ALAMEDA COUNTY
HEALTH CARE SERVICES

May 12, 2006

Subject: SLIC Case RO0002902, Lucasey Manufacturing, 2744 East 11th Street, Oakland, CA 94601 – Work Plan Review

Revised Soil Boring Locations

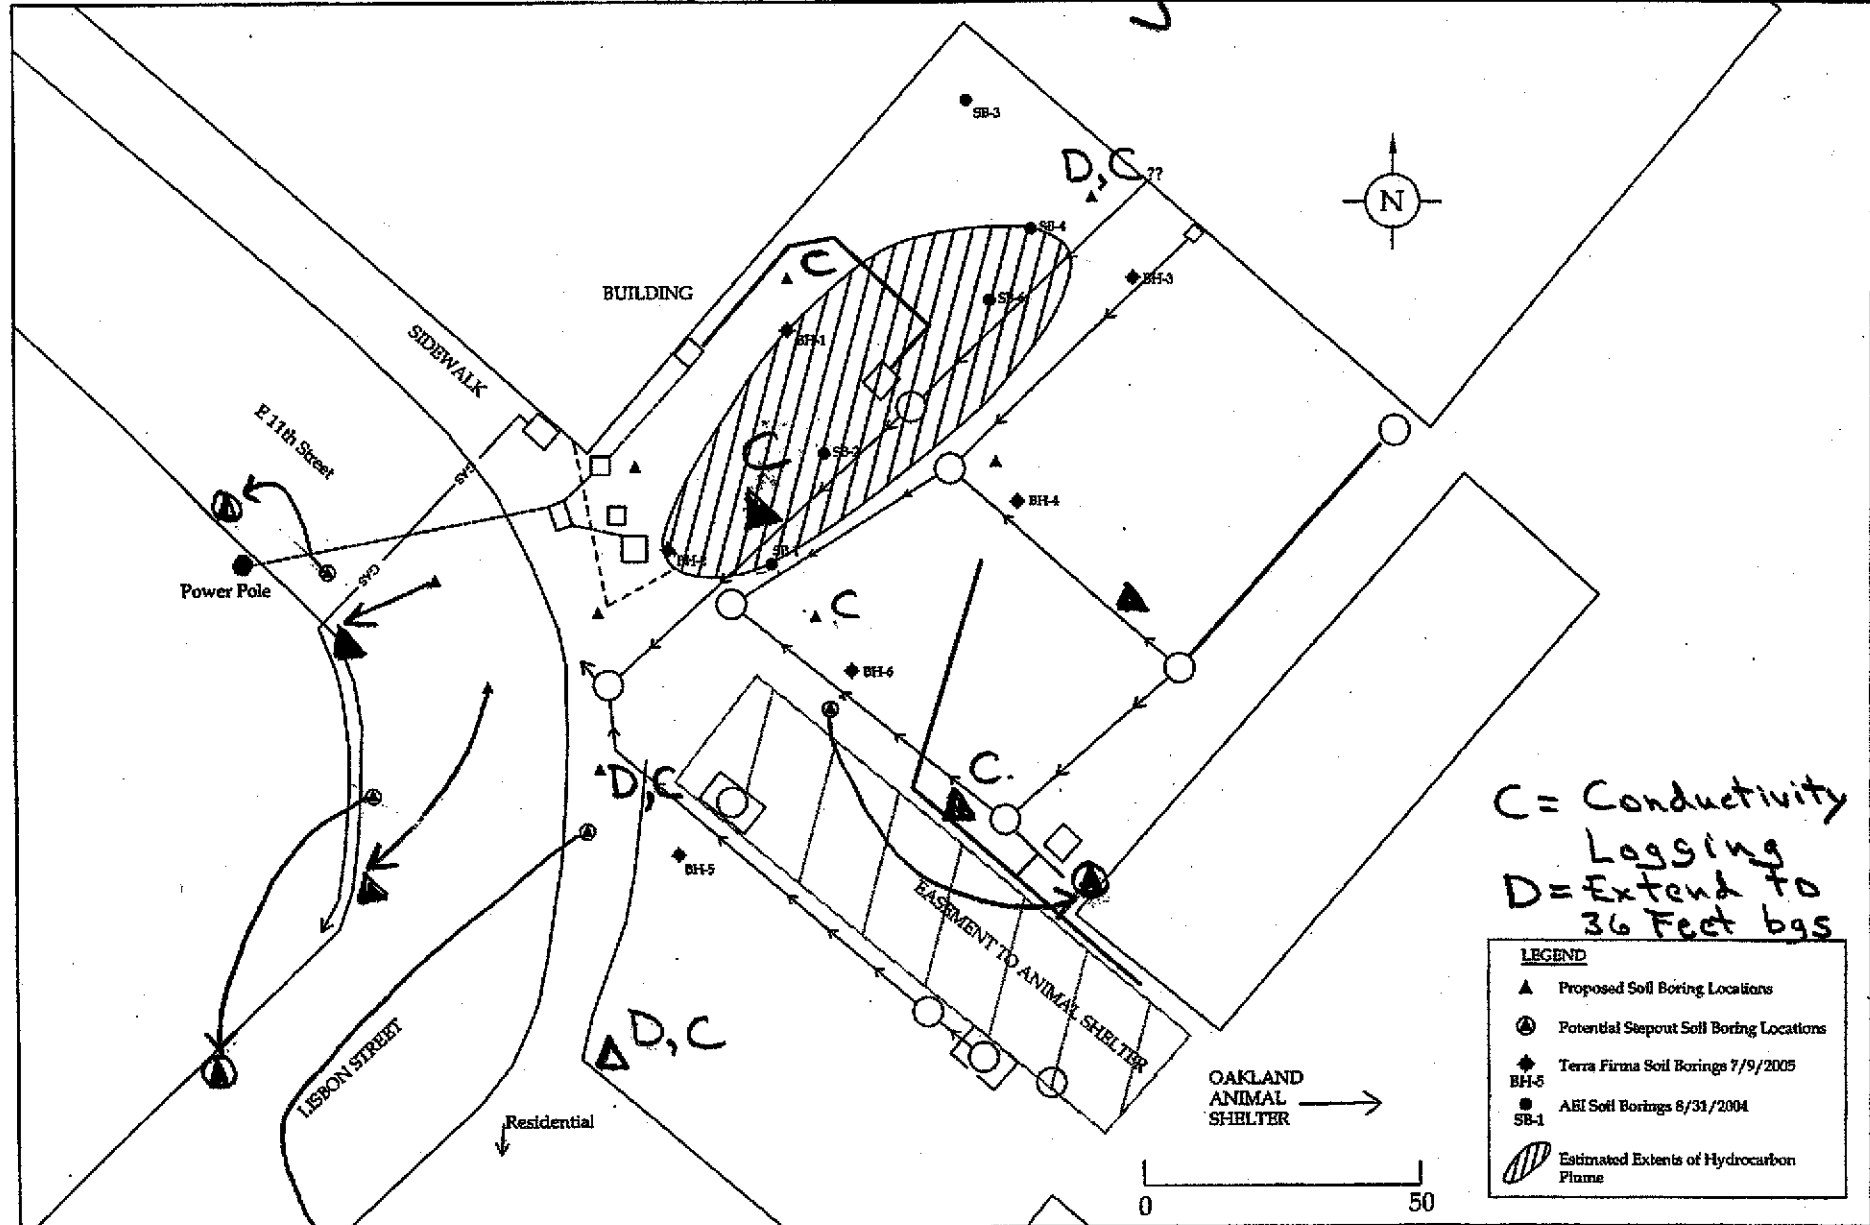
- 1. Base Maps and Plume Extent.** The locations of site features and previous soil borings shown on the Proposed Soil Boring Locations map (Figure 6) differ from the locations of features and previous soil borings shown on Figure 4. Please verify that the locations of site features and previous soil borings on the base map used for Figure 6 are accurate. Please make any necessary revisions prior to conducting the field investigation. If any significant revisions the Proposed Soil Boring Locations map (Figure 6) are necessary, please submit the revised map of boring locations to ACEH for review prior to conducting the field investigation.

- 2. Plume Extent on Figure 6 and Soil Boring Locations.** The "Estimated Extent of Hydrocarbon Plume," which is shown on Figure 6 as a hachured area, significantly underestimates the size of the dissolved phase hydrocarbon plume. The hachured area is approximately the size of the area of probable free product. Several of the proposed borings, particularly those south of the hachured area are north of existing borings where groundwater contamination has already been detected at significant concentrations. Therefore, collecting grab groundwater samples at these proposed locations is not likely to achieve the stated objective of delineating the horizontal extent of the plume. However, these proposed borings are expected to be useful in delineating the extent of free product

and highly elevated concentrations of residual product in soil within the interior portion of the plume. In order to provide delineation of the dissolved phase plume, we have requested additional soil boring locations, which are shown on the attached figure entitled, "Revised Soil Boring Locations." ACEH has no objection to advancing stepout borings based on observed conditions and analytical results from a mobile laboratory. Please advance the additional requested borings shown on the attached figure and present the results in the Soil and Groundwater Investigation Report requested below.

5. **Electrical Conductivity Logging.** Conductivity logging is proposed at "select borings." However, the number and locations of borings at which conductivity logging will be conducted is not specified. At a minimum, we request that conductivity logging be conducted along two transects as shown on the attached figure entitled, "Revised Soil Boring Locations," in order to construct hydrogeologic cross sections for the site. Please present the results of the conductivity logging in the Soil and Groundwater Investigation Report requested below.

C = Conductivity Logging
 D = Extend to 36 Feet bgs
